NL-19-001

April 15, 2019

Subject: License Amendment Request to Revise the Indian Point Energy Center Site
Emergency Plan to Address the Permanently Shut Down and Defueled
Condition

Indian Point Nuclear Generating Units 1, 2, and 3
Docket Nos. 50-003, 50-247, and 50-286
Facility Operating License No. DPR-5
Renewed Facility Operating License Nos. DPR-26, and DPR-64

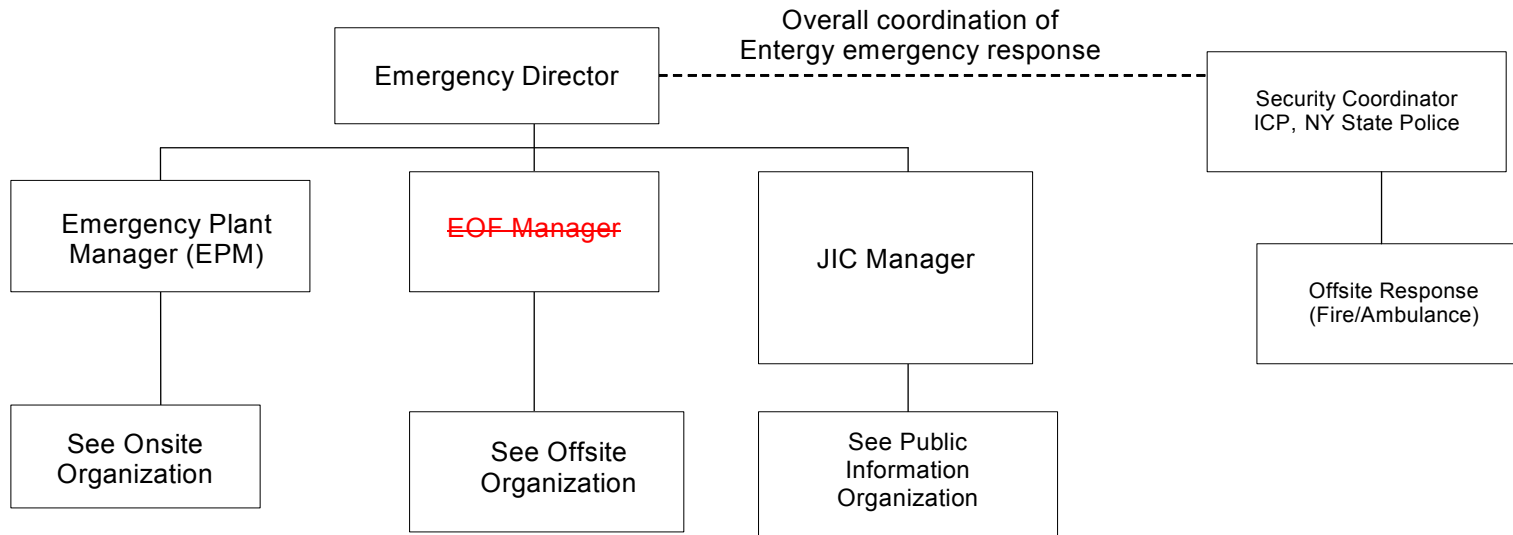
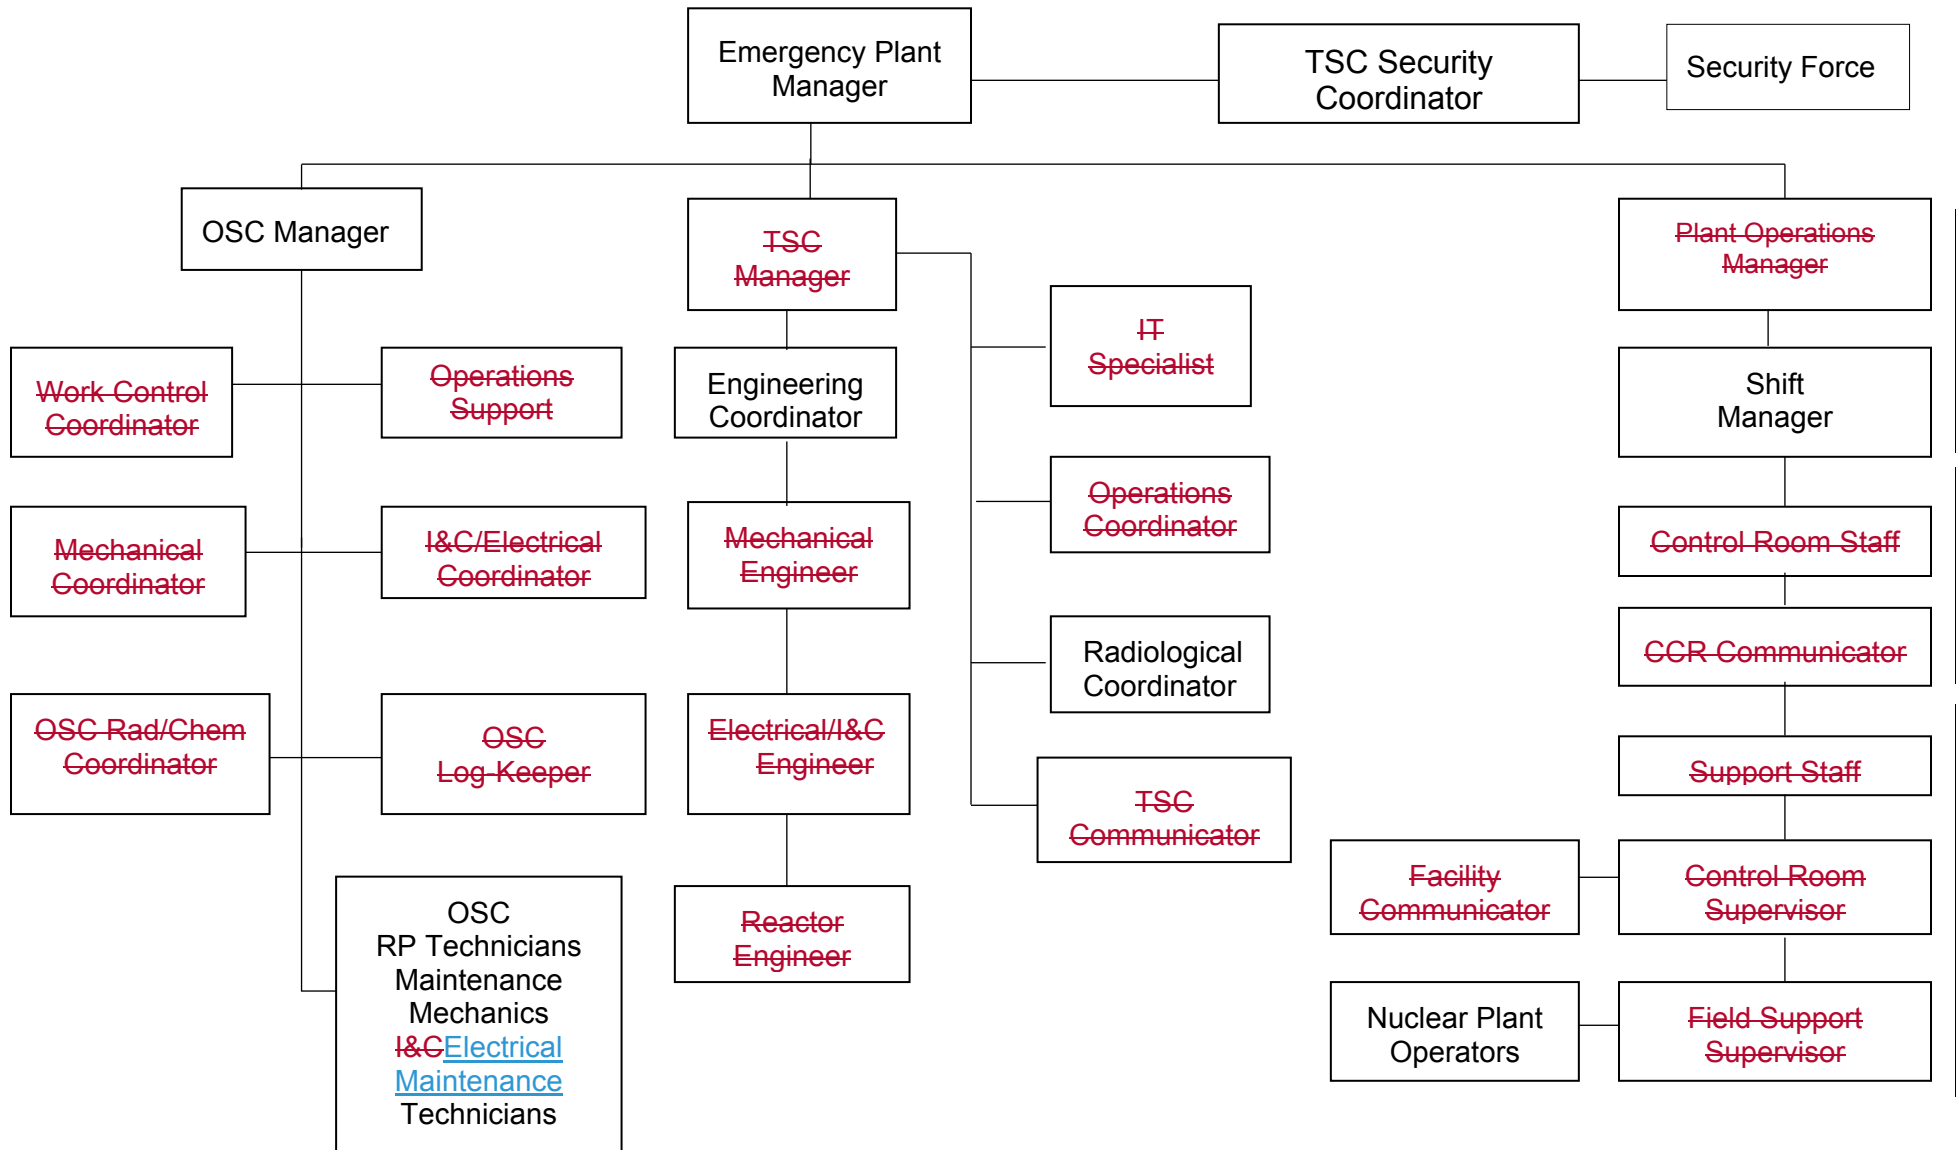
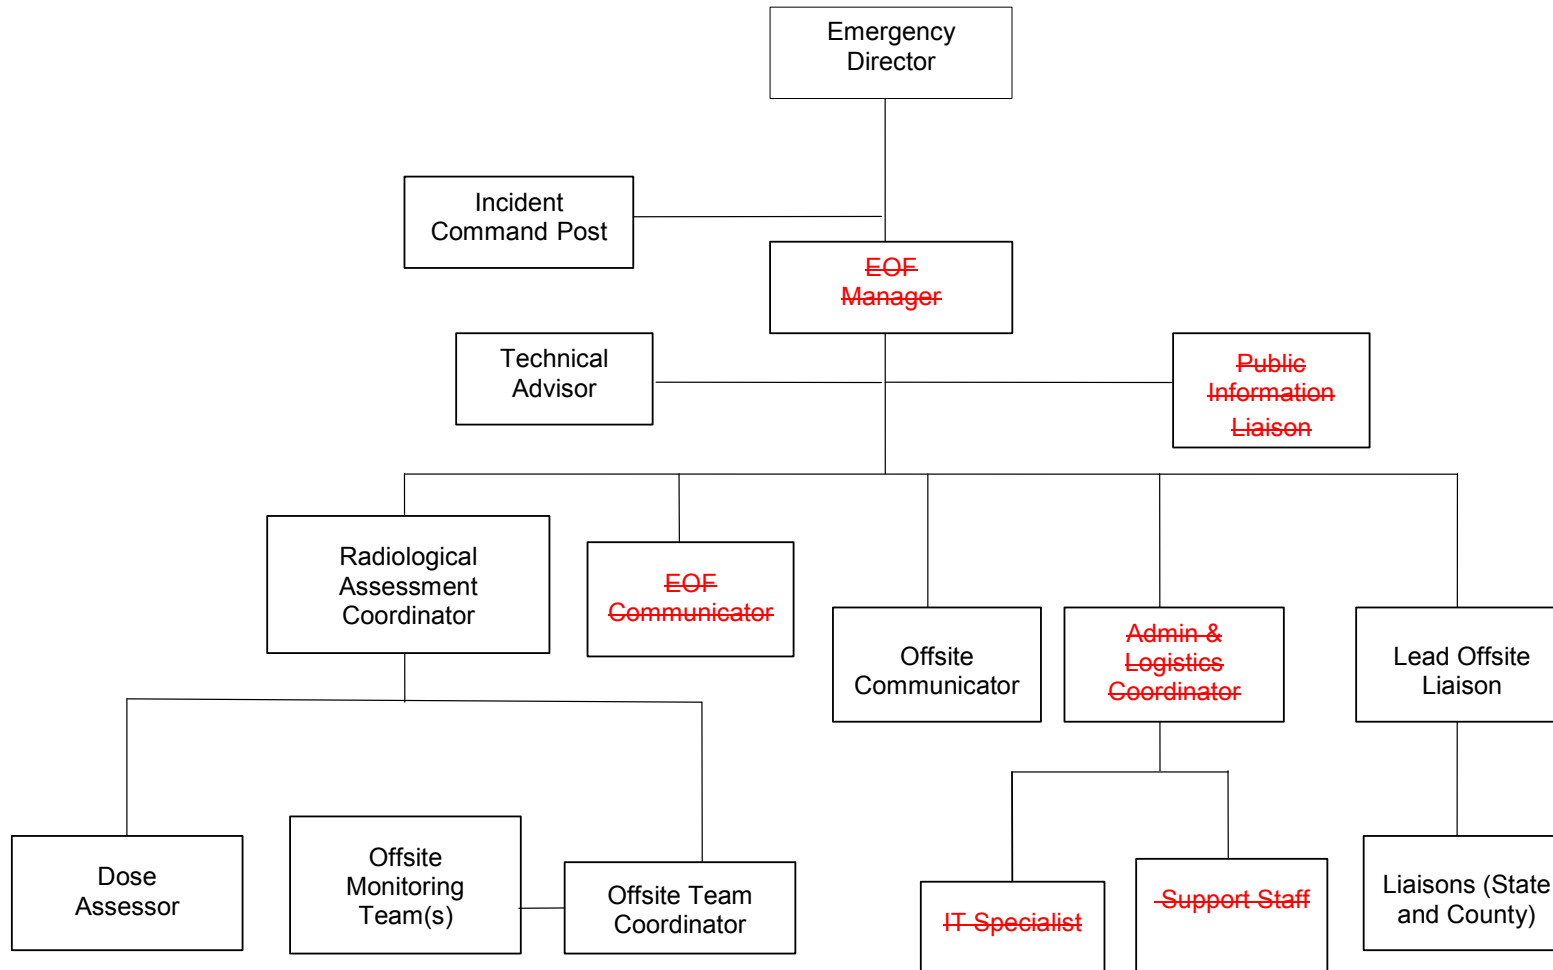
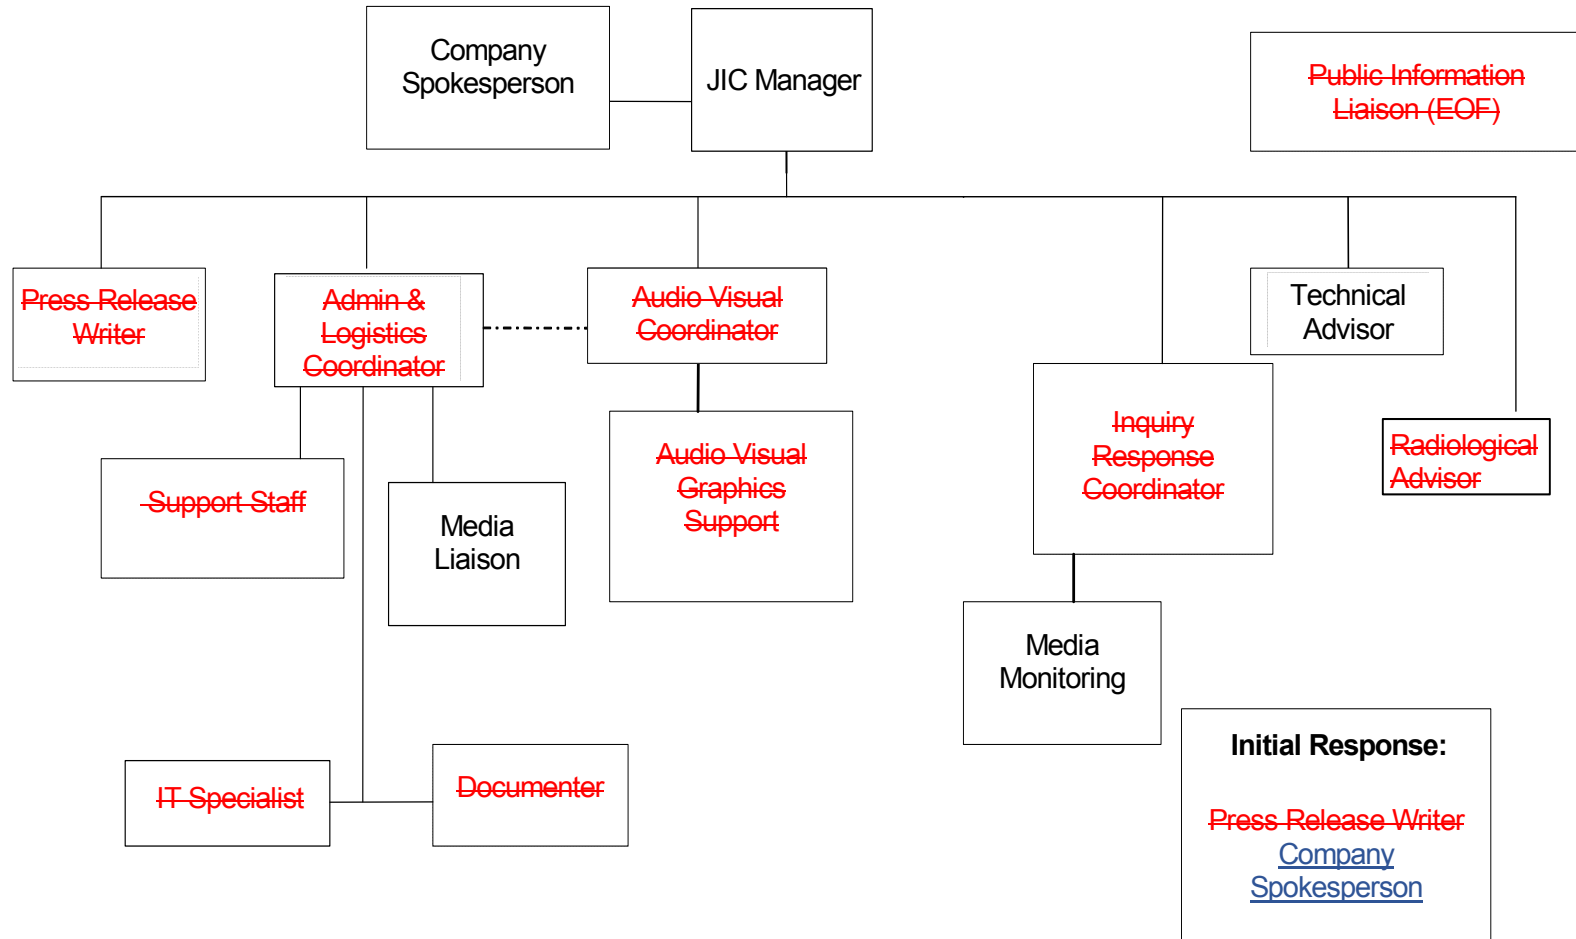
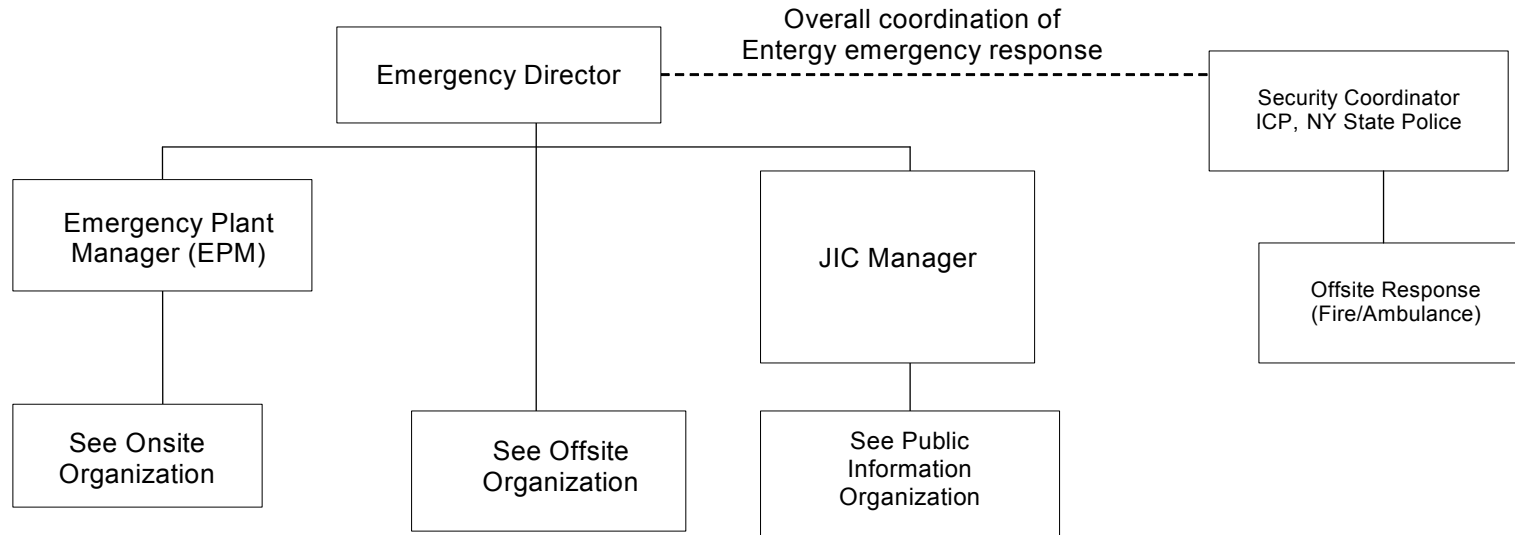
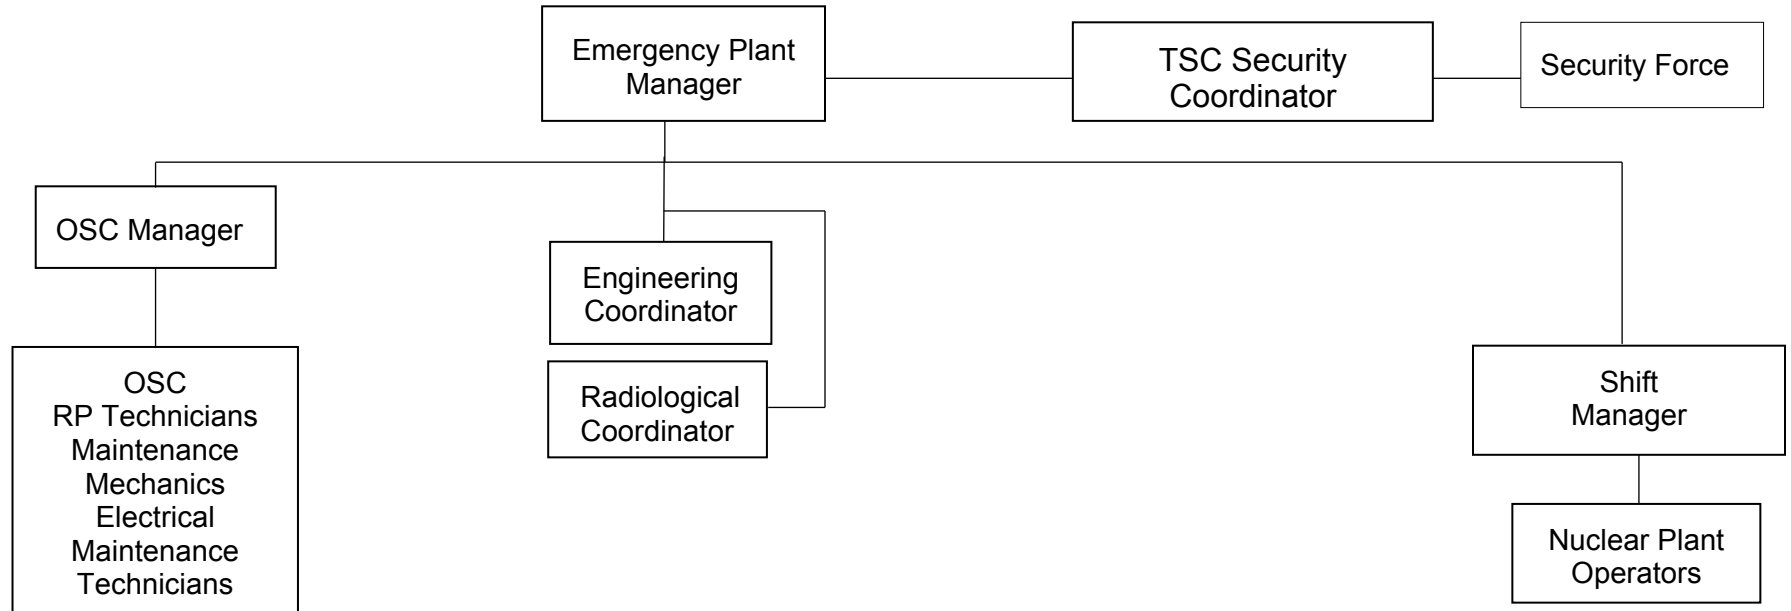
Part 2, Figure B-1.2a, B-1.2b, B-1.2c, and B-1.2d	(See markups)	Figure B-1.2a (Major Areas) is revised to eliminate the following positions: - EOF Manager Figure B-1.2b (Onsite) is revised to eliminate the following positions: - Work Control Coordinator - Mechanical Coordinator - OSC Rad/Chem Coordinator - OSC Operations Support - I&C/Electrical Coordinator - OSC Log Keeper	Following permanent cessation of Unit 3 power operations and permanent removal of fuel from the reactor vessel, numerous positions will not exist in the Permanently Defueled ERO. Duties and responsibilities will be transferred to remaining positions as shown in the proposed revision.

Emergency Plan Section	Before (Stage I Emergency Plan)	After (Rev. TBD)	Reason for Change
		• TSC Manager • Mechanical Engineer • Electrical/I&C Engineer • Reactor Engineer • IT Specialist • Operations Coordinator • TSC Communicator • Plant Operations Manager • Control Room Staff • CCR Communicator • Support Staff • Control Room Supervisor • Field Support Supervisor • Facility Communicator Figure B-1.2c (EOF) is revised to eliminate the following positions: • EOF Manager • Public Information Liaison • EOF Communicator • Admin & Logistics Coordinator • IT Specialist • Support Staff Figure B-1.2d (Public Information) is revised to eliminate the following positions: • Press Release Writer • Support Staff • IT Specialist • Admin & Logistics Coordinator • Audio Visual Coordinator • Audio Visual Graphics Support • Documenter • Public Information Liaison • Inquiry Response Coordinator
